ULNRC-2873

DOCKET NUMBER 50-483

CALLAWAY PLANT

REVISION TO TECHNICAL SPECIFICATIONS 3.8.3.1 and 3.8.3.2
ELECTRICAL POWER SYSTEMS - ONSITE POWER DISTRIBUTION

FIGURE 1 SAFETY-RELATED AC DISTRIBUTION SYSTEM

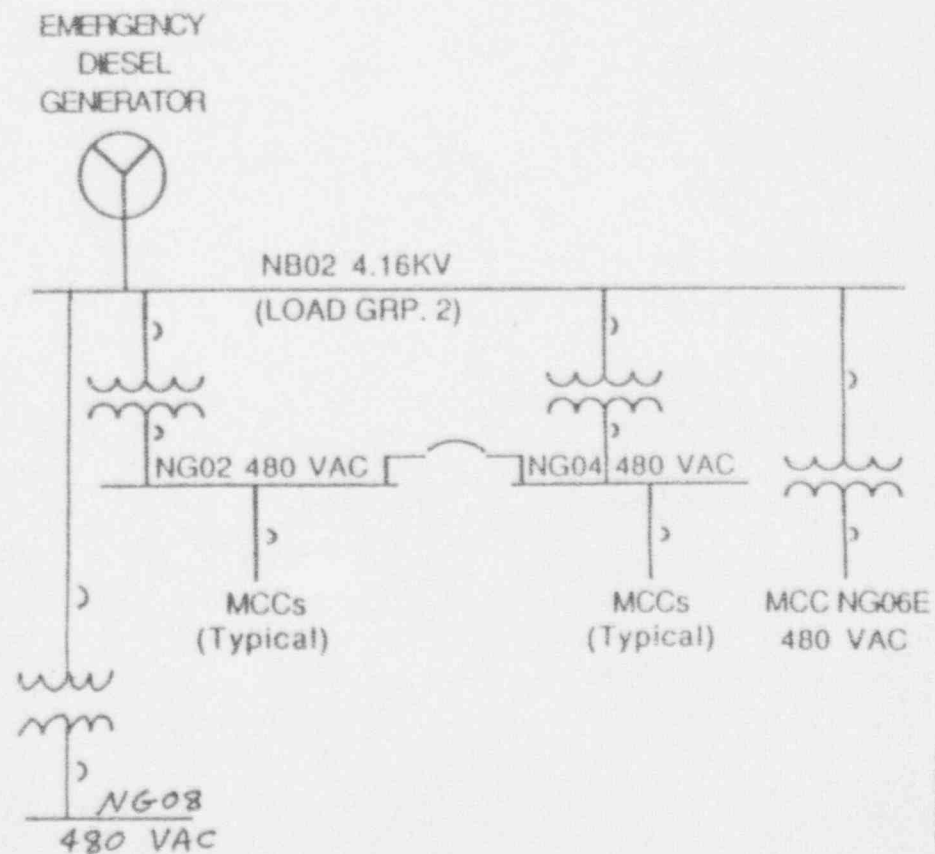
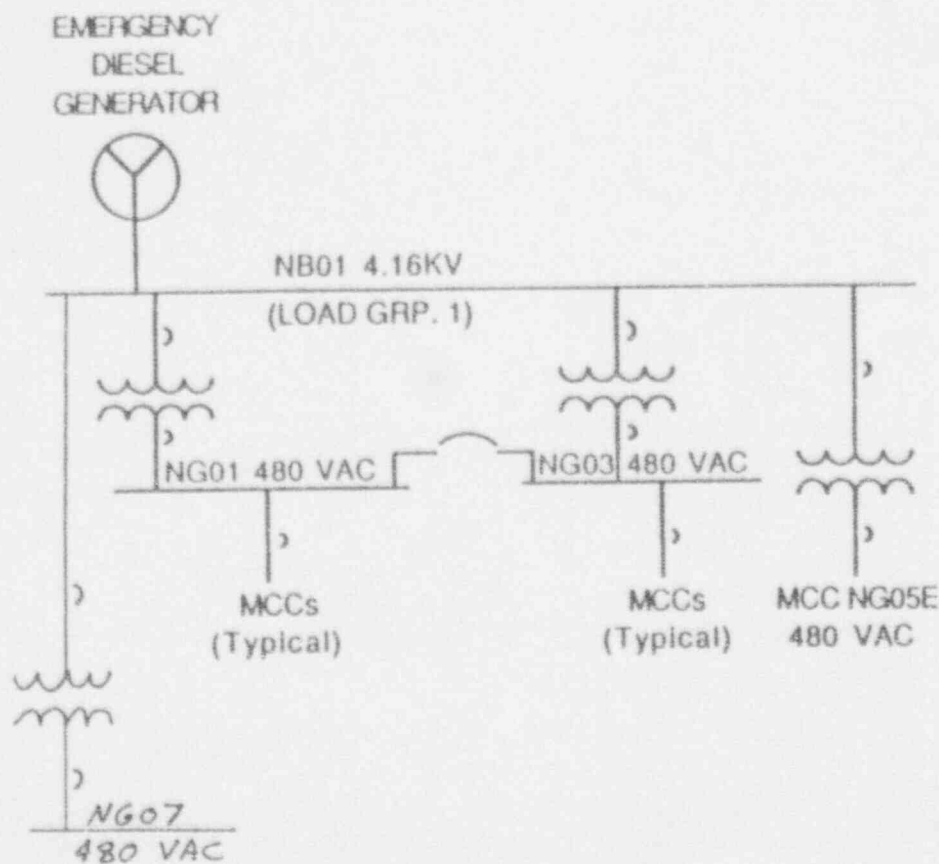
This license amendment request proposes a revision to Technical Specification Section 3.8.3, Electrical Power Systems - Onsite Power Distribution, to make the limiting conditions for operation for four emergency busses (NG05E, NG06E, NG07, and NG08) consistent with other technical specifications. Motor Control Centers (MCC) NG05E and NG06E supply power to only essential service water (ESW) system support equipment. Load Centers (LC) NG07 and NG08 also supply power to only ESW system support equipment, primarily the Ultimate Heat Sink (UHS) cooling tower. The proposed revision will make the allowed outage time (AOT) for any of these emergency busses 72 hours. This is equivalent to the AOT for one train of the ESW per Technical Specification 3.7.4 and equivalent to the AOT for one train of the UHS cooling tower per Technical Specification 3.7.5.

This amendment request also proposes to add Load Centers NG07 and NG08 to the listing of emergency busses in Technical Specifications 3.8.3.1 and 3.8.3.2. These LCs provide emergency power to only the UHS cooling tower and other ESW support system equipment. The proposed addition would also allow the deenergization of LC NG07 or LC NG08 for up to 72 hours, which is equivalent to the allowed outage time for one train of the UHS cooling tower per Technical Specification 3.7.5. Thus, this change will provide consistency between the specifications for the ESW system and the emergency A.C. power distribution system.
